WELL NAME: WILD TURKEY 23-5, API #: 071-06624, INSP. # 716301120

COLORADO
Energy & Carbon Management
Commission
Department of Natural Resources

PHOTO 7: PHOTO SHOWING LEAKING DRIVEHEAD MENTIONED IN PREVIOUS PHOTO.

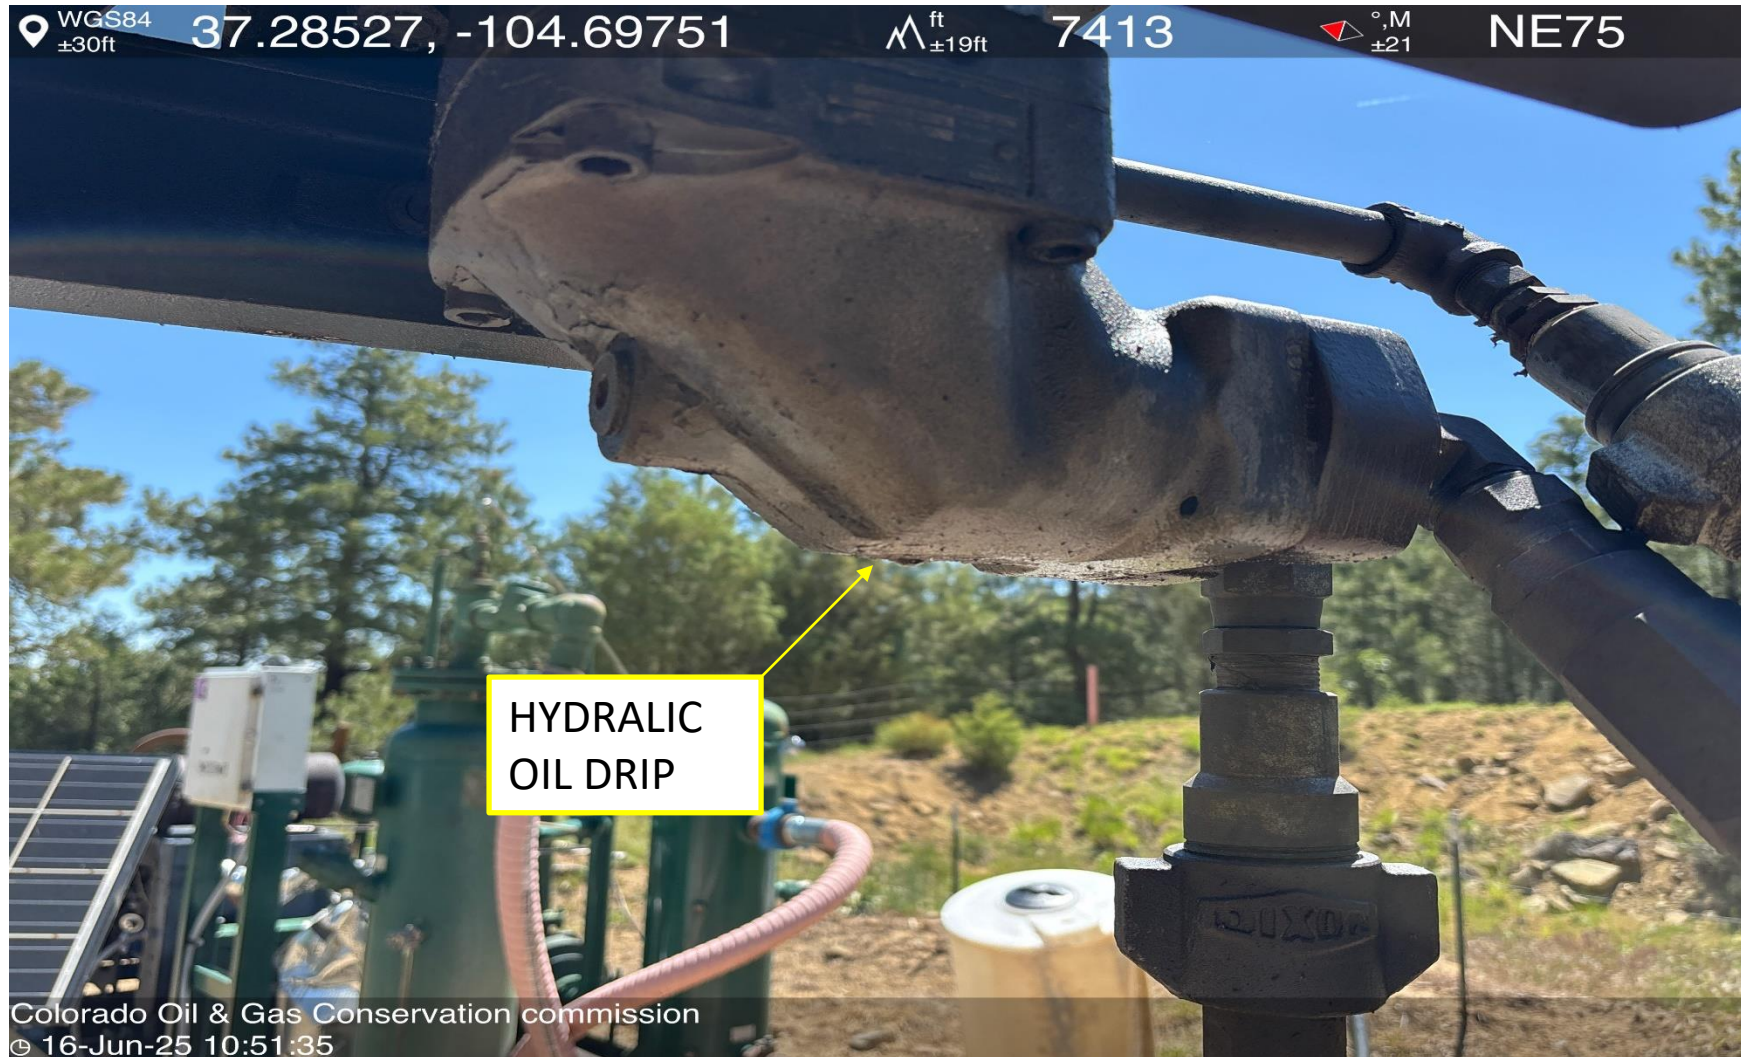
PHOTO 6: AREA OF IMPACTED SOIL AROUND WELLHEAD APPEARS TO BE FROM LEAKING DRIVEHEAD MOTOR SHOWN IN NEXT PHOTO. Conduct maintenance on equipment, cleanup stained material and review self inspection processes. COMPLY WITH RULE 1002,.(2).D. CA DATE 6-25-2025.

HYDRALIC
OIL DRIP
